Interactive comment on “Modeling subsurface transport in extensive glaciofluvial and littoral sediments to remediate a municipal drinking water aquifer” by M. Bergvall et al.

Received and published: 20 April 2011

Fig. 1. Figure A

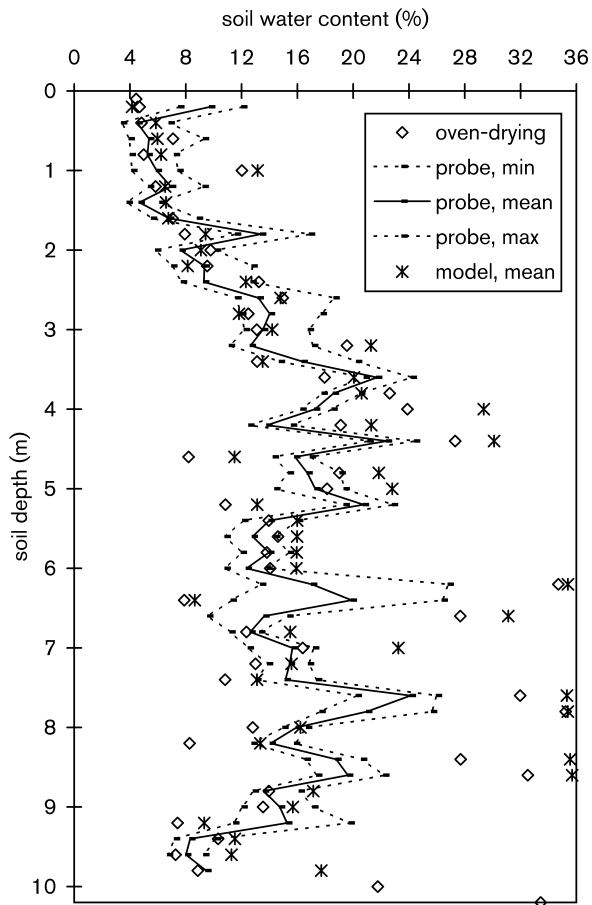
4. (4) The role of the vadose zone modelling remains almost in the dark. The calibration gives some answers, but results for simulation and measurement should be shown also in terms of water contents and pesticide concentrations in the vadose zone.

31. Page 1739, Line 23: “The van Genuchten-Mualem parameters were calibrated against water content measured at 51 depths on 13 occasions. The mean error of the total water balance was 1.3%.” If the water balance was known, why was this information not used in the model calibration to better constrain the model? Was the calibration for water and solute done sequentially (literature says its better to do it simultaneously to utilize mutual dependencies). And the statement does not tell if this calibration is for one point only, or for several sites – the profile hydraulic properties certainly show spatial variability?

to be better explained. We would add Fig. A with observed and simulated water contents as shown above. At P1739 L27 we would add the following: ‘The root-mean of squared differences for the validation data gave a corresponding error of 24 %. The infiltration rate and the generated bottom water flux at 10.2 m depth are shown in Fig. B (see below). The figure shows a seasonal variation of the bottom flux.’ We would add Figures B, C and D that show infiltration rate, observed and modeled dichlobenil concentrations, and simulated water flux, mass fluxes and concentrations of BAM at the bottom of the model. The analyzed dichlobenil concentrations found in Fig. C would also be added to Table 1.

Reply: We would add Fig. A to clarify how the flow model was calibrated. We would revise the text at P1739 L23-27 to: ‘The water flow and the solute transport models were calibrated sequentially. The van Genuchten-Mualem parameters including saturated hydraulic conductivity were calibrated against water contents analyzed by the oven-drying method, and then validated with the moisture probe data obtained at the hotspot (Fig. A). The mean error of the total water balance was 1.3 %. The root-mean of the squared differences between the calculated and observed water contents obtained by the oven-drying method was normalized by the observed range, giving a calibration error of 10 %. The root-mean of squared differences for the validation data gave a corresponding error of 24 %. The infiltration rate and the generated bottom water flux at 10.2 m depth are shown in Fig. B. The figure shows a seasonal variation of the bottom flux.’

FIGURE CAPTIONS: Figure A. Observed and simulated water contents in the soil profile that were sampled in 2003. The water content data obtained by the oven-drying method was used to calibrate the vadose zone model. The minimum, mean, and maximum values of water contents were obtained from measurements by the soil moisture

Fig. 3. Figure C

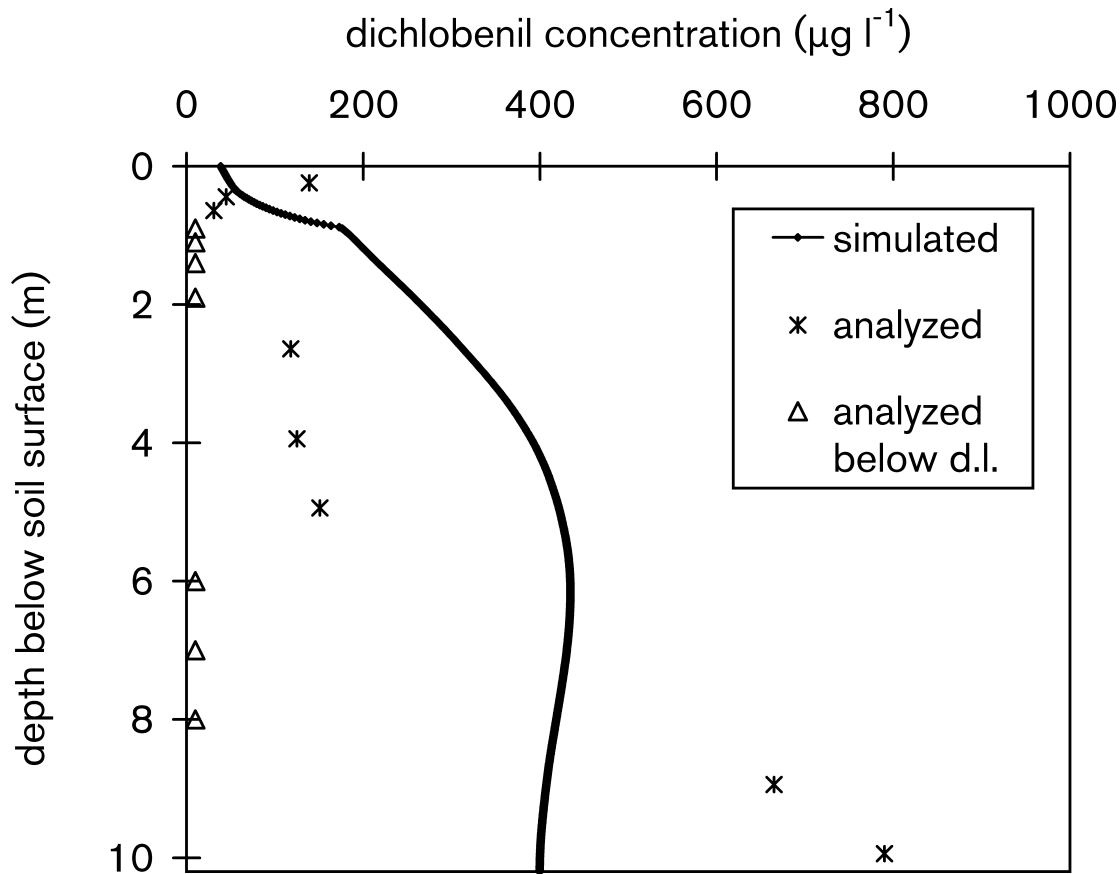
32. Page 1739, Line 27: “The solute component of the model was calibrated to achieve the best match between the calculated and observed concentrations of dichlobenil and BAM, in the solid and solute phases.” Fitting which parameters? Fitted at what place – an average of the 5 sampling locations at nursery area? If stated above, briefly repeat here for clarity. Perhaps refer to results from sensitivity analysis (some ‘see below’ statement) used to identify the important parameters to be fitted.

Reply: We would add Fig. C to clarify how the solute model was calibrated. We would revise the text at P1739 L27-P1740 L2 to: ‘The solute component of the model was calibrated to achieve the best match between the calculated and observed hotspot-concentrations of dichlobenil in the solid and solute phases (Table 1, Fig. C). The sensitivity analysis that was undertaken, Eq. (5), helped to identify the important parameters to be fitted. Since the observed concentrations had high variability the obtained fit to simulated concentrations was only in the same order of magnitude. The root-mean-squares of the residuals of the adsorbed and liquid phases were normalized by the observed concentration range giving calibration errors of 38 % and 39 %, respectively. Concentrations and mass fluxes of BAM that were generated by the prediction model at the bottom of the vadose zone are shown in Fig. D.’

Figure C. Simulated and analyzed concentrations of dichlobenil at one identified hotspot (Fig. 2) in the vadose zone of the nursery field. The detection limit (d.l.) of the analyzed samples was about $10 \mu\text{g l}^{-1}$. The date of calibration was 1st November 2003. The assumed application rate of dichlobenil was 1.7 g m^{-2} , applied at 24 times between 1976 and 1991.

Fig. 4. Figure D

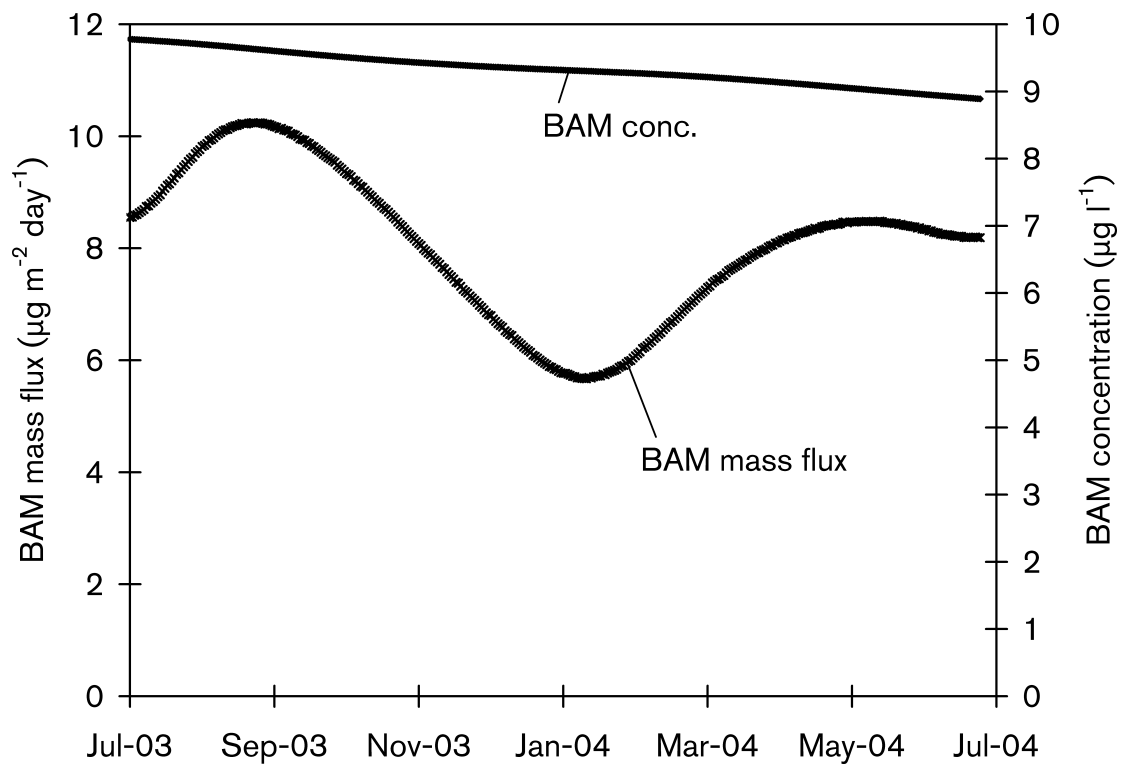
6. (6) Could you show simulated time series of concentrations and fluxes at the 10-m

deep bottom of the vadose zone, serving as input to the GW model? Perhaps these can be compared to simulation results of the mass-balance model. Perhaps mean transit times are similar, but peak events differ. How could this affect overall transit times towards the extraction wells? Can you better demonstrate the benefit of using your coupled approach?

Reply: We would add a figure showing concentrations and fluxes at the bottom of the vadose zone (see above, Fig. D). At the bottom of the vadose zone the mass fluxes of BAM (Fig. D) corresponded with the variation of water fluxes (Fig. B), and resulted in stable BAM concentrations with small variations from day to day (Fig. D). With the groundwater model we also studied the transport of a solute pulse with ten times higher concentration compared to the mean. A 1-day long pulse was applied in August 2000 (a year with many heavy rainfalls) as input to the groundwater model. The pulse became clearly visible in the extraction wells and had in 2004 a maximum concentration, which was $0.20 \mu\text{g/l}$ higher compared to the presented model result. When we applied a similar pulse, but 30-day long, it resulted in, at the most, $0.23 \mu\text{g/l}$ higher concentration in the extraction wells compared to the presented model result. Comparing these results to the variability of the analyzed BAM concentrations we believe that local variability in mass fluxes will be mixed at regional scale. At P1744 L25 the following text would be added: 'The transit time of groundwater from the northern to the southern end of the nursery was calculated to be more than one year, implying that local variability in mass fluxes will be mixed at regional scale.' We would better explain the benefit of using our coupled approach, and the following text would be added at P1745 L20: 'Despite the prediction ability of the simple mass-balance model in coarse-grained settings, the distributed numerical model should be used if the contaminant transport needs to be calculated more accurately, e.g. to predict concentrations at a specific point or to evaluate remediation strategies.'

Figure D. Simulated mass fluxes (left y-axis) and concentrations (right y-axis) of BAM at the bottom of the 10.2 m deep vadose zone model. The daily outflows and concentrations of BAM were generated by the vadose zone model from 1st July 2003 to 30th June 2004. The assumed application rate of dichlobenil was 0.17 g m^{-2} , which was ten times lower than the rate in the calibrated model. The BAM concentrations from the vadose zone model were used as input to the groundwater model.
